EMERGENCY DROUGHT APPLICATION: GROUNDWATER REVIEW

SUBJECT: Application G- 19137

DROUGHT MITIGATION; GROUNDWATER

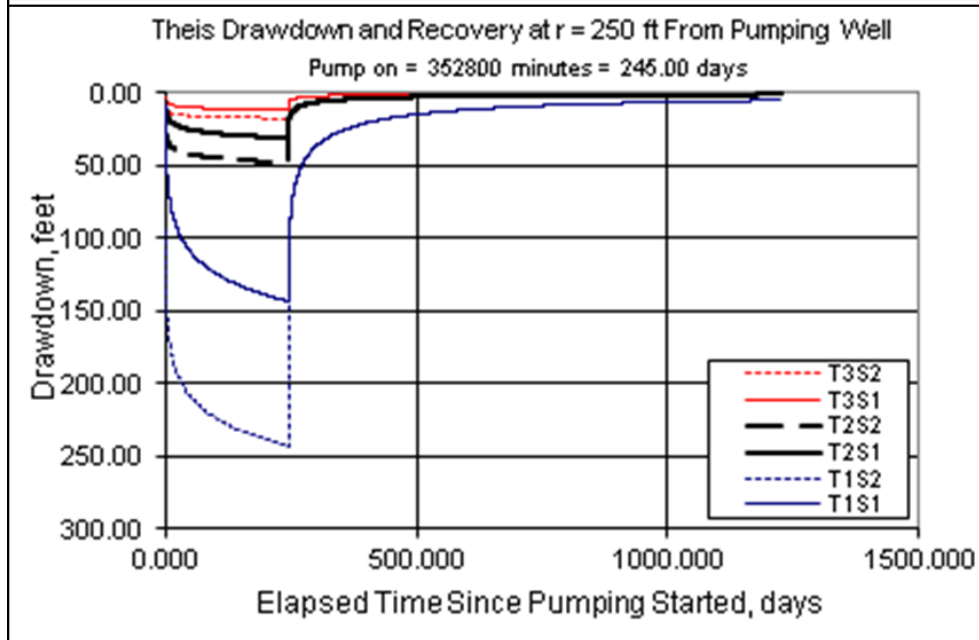
A4. **Comments:** The applicant proposes to construct a well between 100 and 600 feet deep in order to provide supplemental irrigation to lands authorized for surface water irrigation under Certificates 73167 and 4053. No metes and bounds were submitted, well location approximated using latitude and latitude provided by applicant.

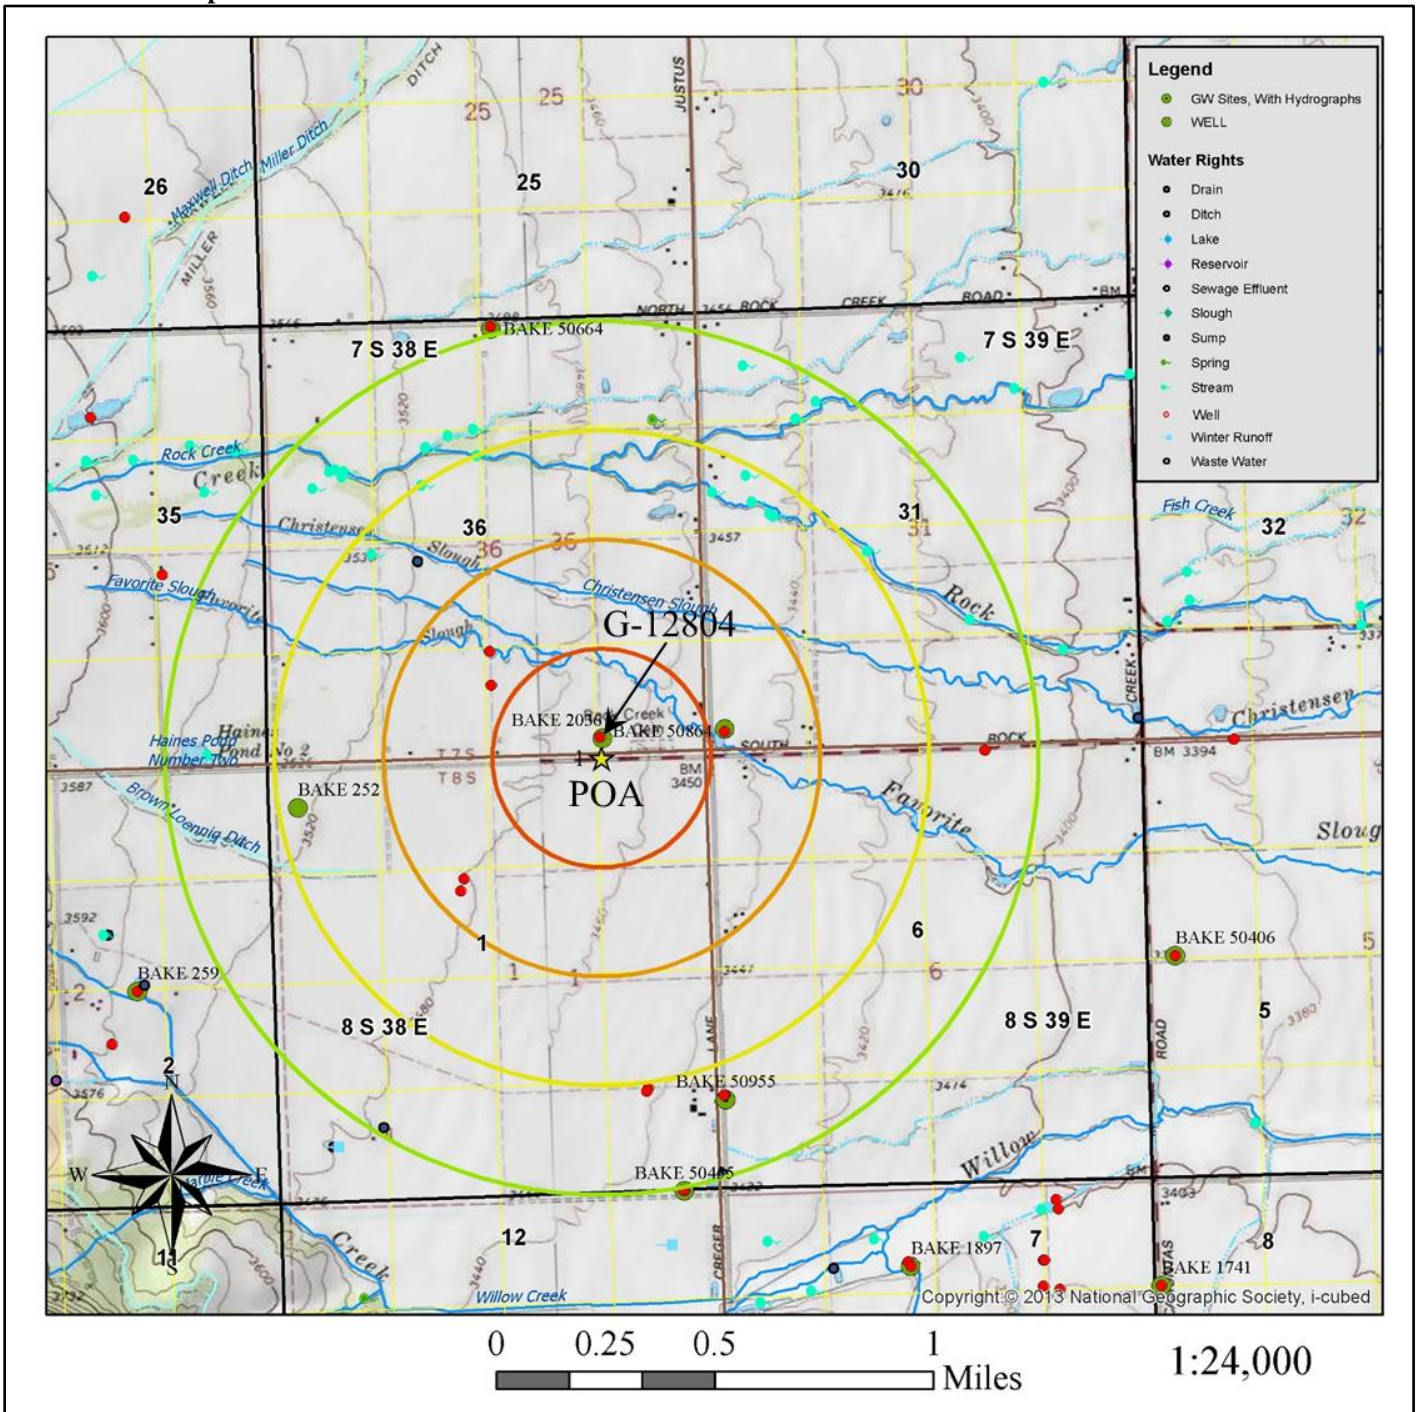
B2. Is there information that this drought groundwater use will **injure senior groundwater rights** during the duration of the drought declaration? (Yes) (No) If yes, explain: The proposed POA location is 240 feet from existing well BAKE 2036, which is authorized under permit G-12804. Using a range of values for hydraulic conductivity from nearby pump tests, seasonal impacts were predicted to range from less than 20 feet to greater than 200 feet, using the maximum proposed rate. Note that BAKE 2036 does not fully penetrate the alluvial aquifer, with a total depth of 160 feet, and therefore no finding of injury was made despite the expected hydraulic interference from this proposed use.

A range of values from local pump tests were utilized for estimation of expected seasonal drawdown at nearby BAKE 2036 as a result of pumping at the proposed POA location. The resulting calculations illustrate the effects of a large variability in transmissivity in nearby tested wells.
